At last week's, May 24, Public Hearing on Lehigh Permanente's Reclamation Plan a request was made by a member of the Santa Clara County Planning Commission for documentation on my testimony that I believed there exists extensive connectivity in groundwater underflow from quarry site to the unconfined aquifer zone where prime drinking water wells are located, and that monitoring wells for contaminants are needed in zone.

Lehigh Permanente Quarry Reclamation Plan Amendment, 211742
Figure 4.10-2
Project Area Monitoring and Sampling Locations

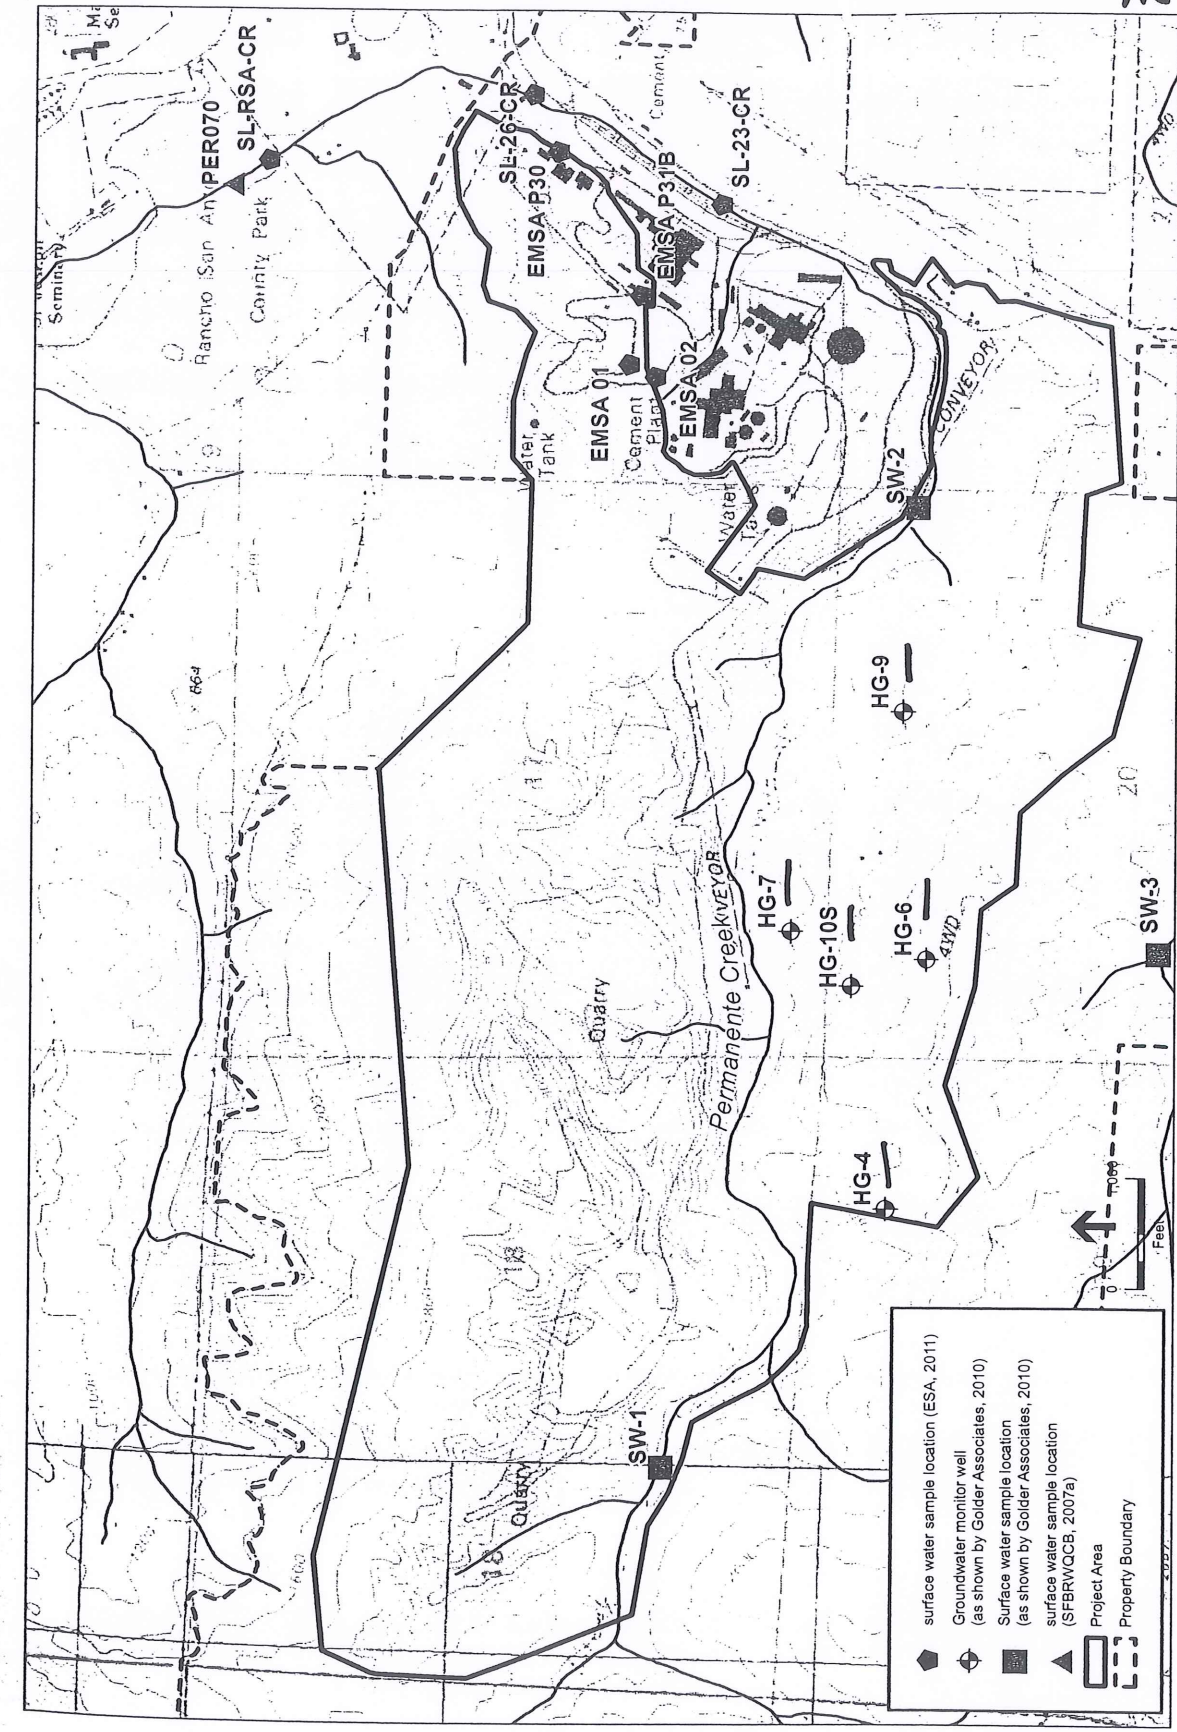
*rationale?
where will selenium concentrations be assessed in ground water below quarry?*

PERMANENTE QUARRY GROUND WATER MONITORING WELLS - UPLAND SITES HG 4, 6, 7, 9, 10S
